RE: Milkwood Manor Updated SDP and Conceptual Pack

Renovation of Milkwood Manor House and Expansion of the Public Car Park at Lookout Beach, Plettenberg Bay.

Aquatic Biodiversity – Specialist Assessment

Figure 2: Preferred SDP (beach showers circled in green and ablution block circled in orange).

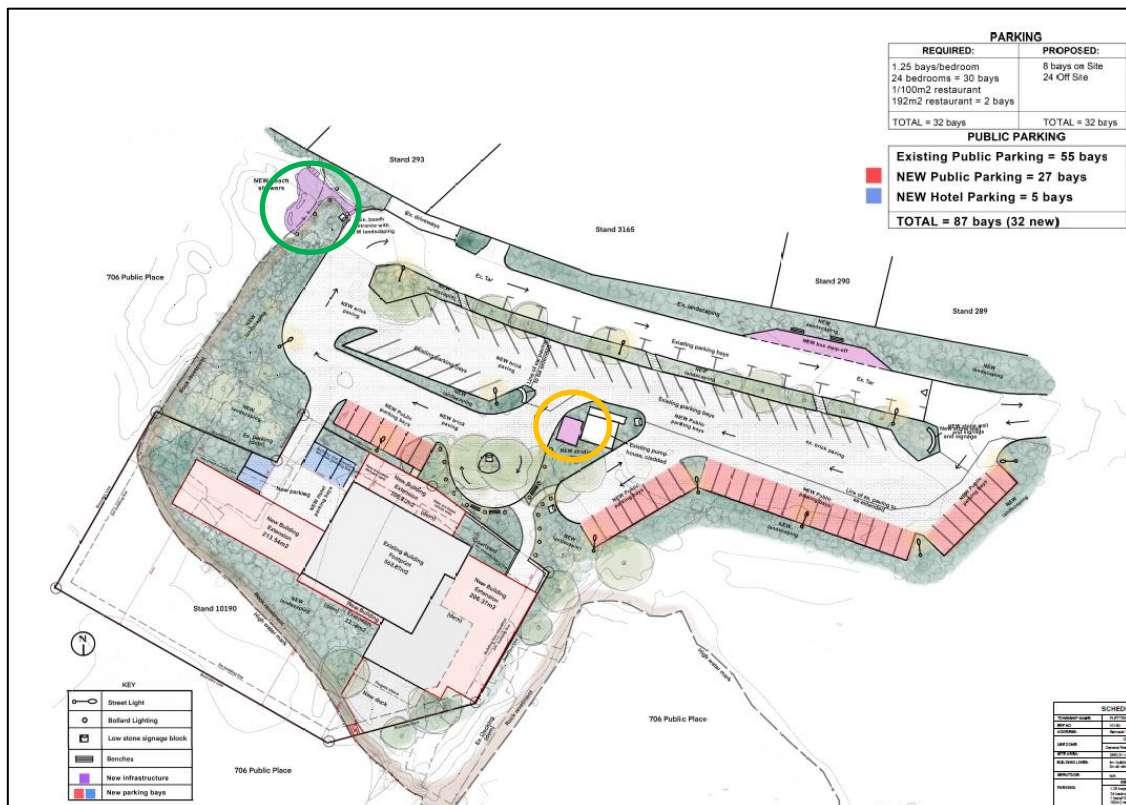
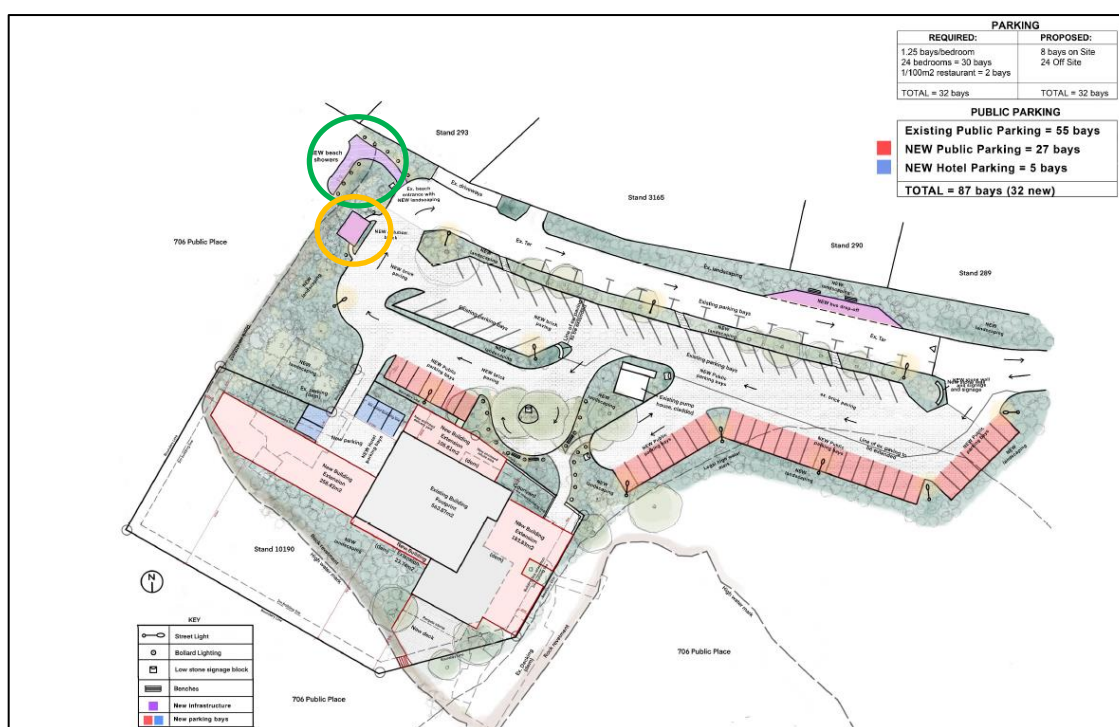
I have had a look at the New Preferred and New Alternative layouts and am certain that these layouts will not result in an any additional impacts or any increase in the significance of impacts that have already been assessed in the report that I have compiled for this development.
